RECEIPT DATE: 6/15/16 **ONSITE SEWAGE DISPOSAL SYSTEM** P 558759

PROPERTY ADDRESS: 11954 Queen Street TAX ID: 05-433355

The BAT Plan submitted on June 1<sup>st</sup> has been reviewed with the following comments.

Approved Septic System Plan  
 Howard County Health Department  
 Hank Oswald  
 Signature Date

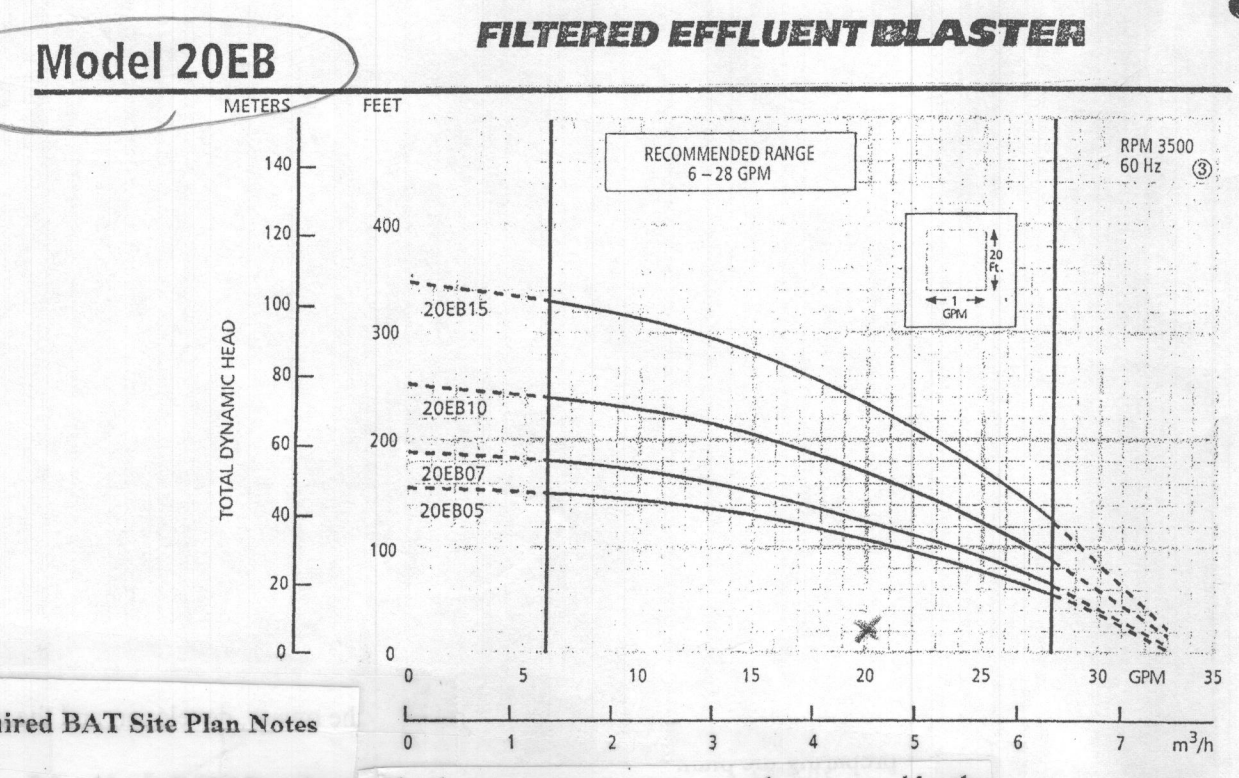
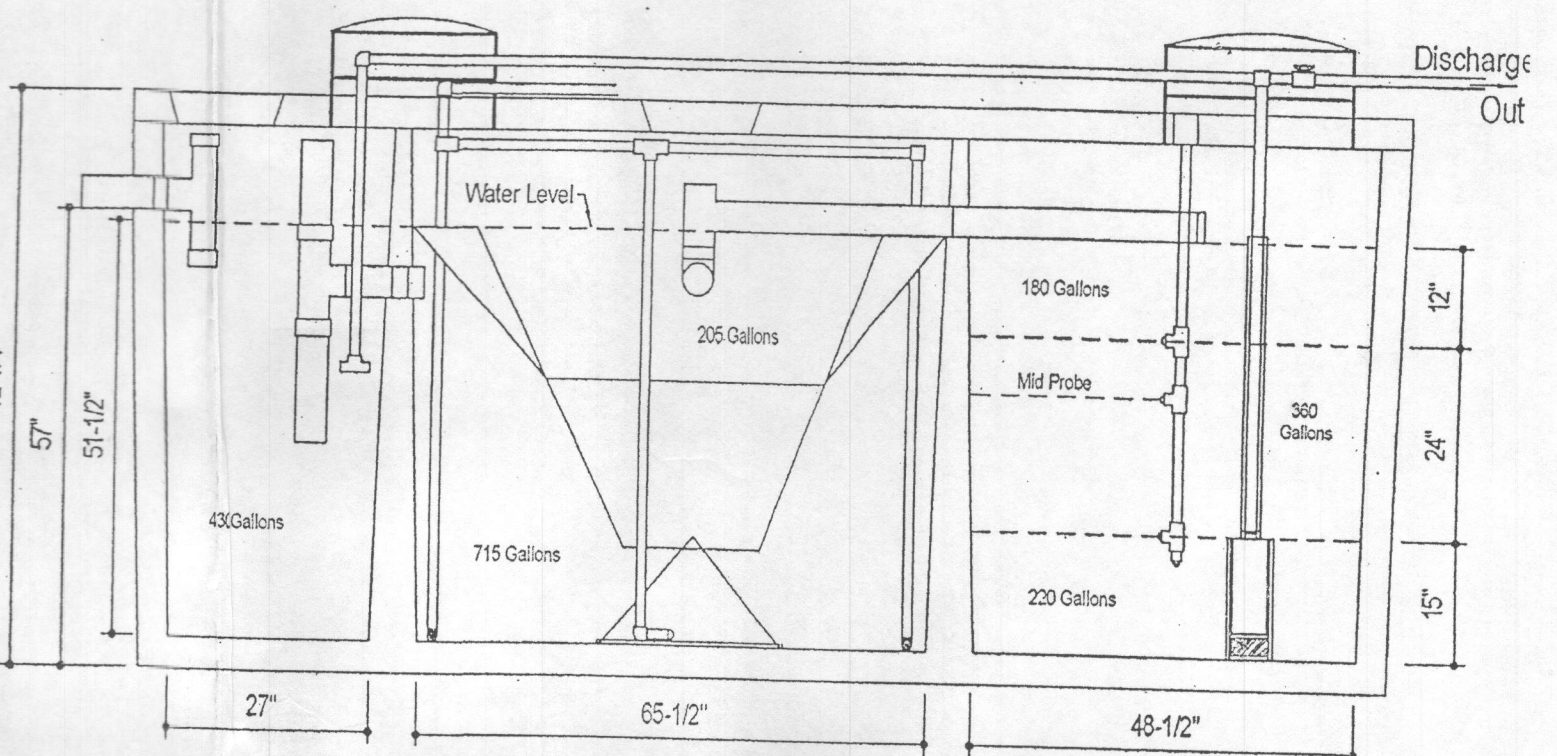
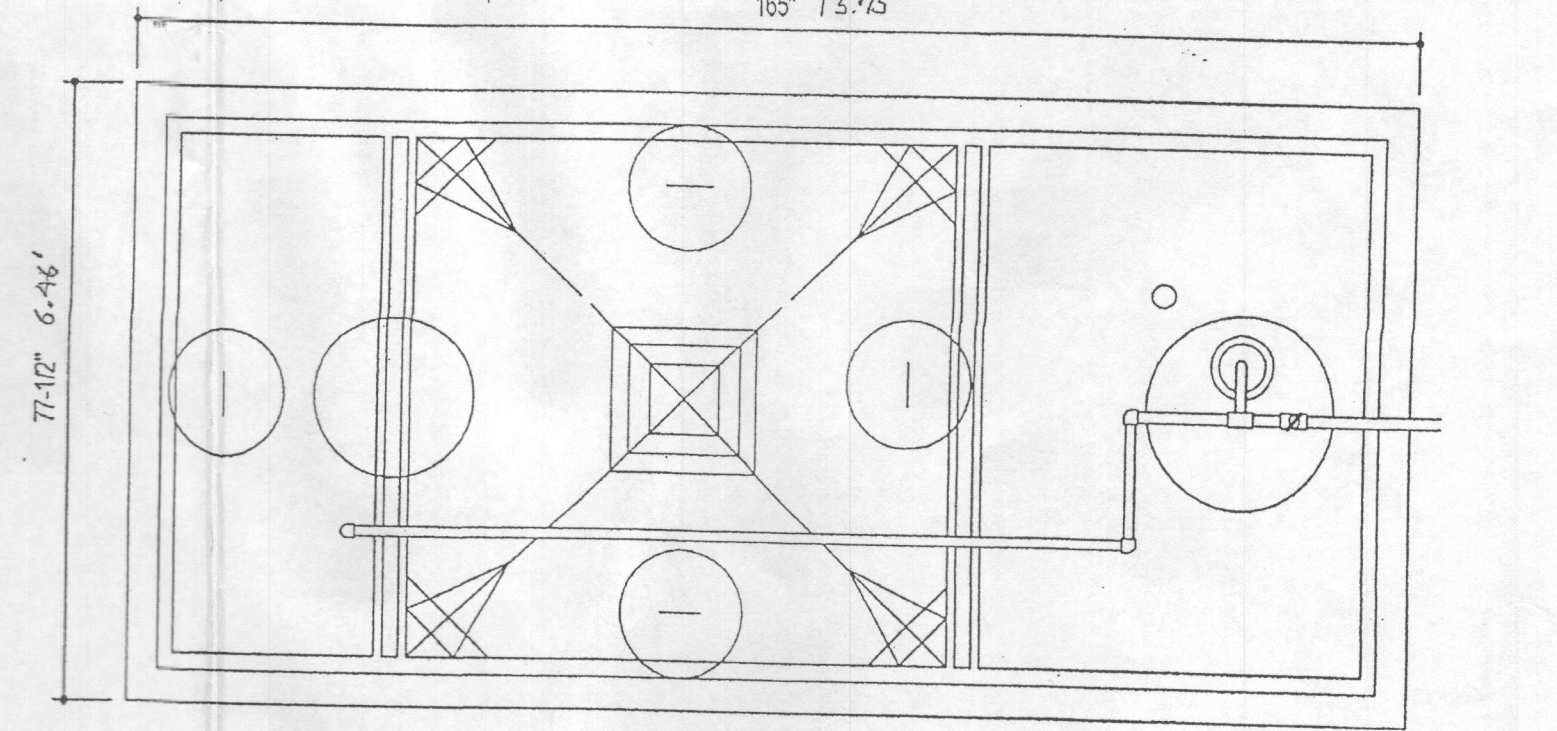
- A.) Add Dynamic Head Calculation -  $DH = \text{Static Head} + \text{Friction Head}$  (Plot point on pump curve)
  - 1.) Static Head = Elevation of highest component of distribution system minus the relative elevation of the pump off float switch
  - 2.) Friction Head = Head loss due to friction in pipe between pumping chamber and distribution system.
- B.) Add pump runtime (usually around 2 minutes) and dose amount to plan
- C.) Add pump make and model.
- D.) Add required BAT Site notes (8 or 9 standard notes).

- Add total dynamic head calculation and plot point on the pump curve.
- Add runtime/dose amount
- Designate Pump on Plan
- Add Required BAT Site Plan Notes (See attachment)

**DESIGN HEAD**  
 DESIGN HEAD = STATIC + FRICTION + DISTAL HEADS  
 STATIC HEAD = DISTRIBUTION BOX INLET - PUMP INTAKE = 462 FT - 442.5 FT = 19.5 FT

**DISTAL HEAD = 3 FT**  
 DESIGN HEAD = 19.5 FT + 2.4 FT + 3 FT = 24.9 FT - 25 FT

**DOSE DESIGN**  
 ELECT TO USE TIME DOSING  
 HOOT CONTROLLER TO BE SET FOR TWELVE (12) DOSES/DAY  
 DESIGN FLOW = 750 GAL / DAY  
 750 GPD / 12 DOSES = 62.5 GAL / DOSE  
 FLOW = 20 GPM  
 DOSE DURATION (MIN) = 62.5 GAL / DOSE / 20 GPM = 3.125 MIN  
 USE THREE (3) MINUTES / DOSE  
 PUMP MUST DELIVER 20 GALLONS PER MINUTE AT TOTAL HEAD OF 25 FT  
 RECOMMEND Goulds Model 20EB05 BLASTER  
 THIS PUMP SUPPLIED AS STANDARD TO HOOT BNR 600 TREATMENT SYSTEM (SEE ATTACHED SPECIFICATION SHEET)
